## Autoblend System on Force Outboards

a - Spring P/N 686300  
b - Retainer P/N 686096  
c - Diaphragm

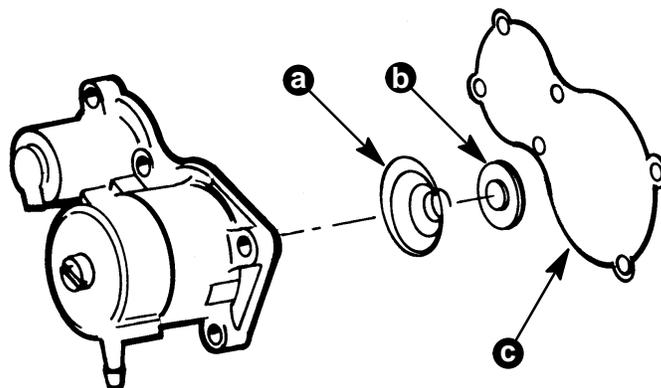
The Autoblend System can also be installed on any Force Outboard 35 HP thru 125 HP if the booster spring and retainer is installed in the fuel pump.

Part Numbers for these items are:

F686300	Booster Spring
F686096	Retainer

**NOTE:** It is always good practice to replace the fuel pump gasket and diaphragm when installing the booster spring and retainer in older engines.
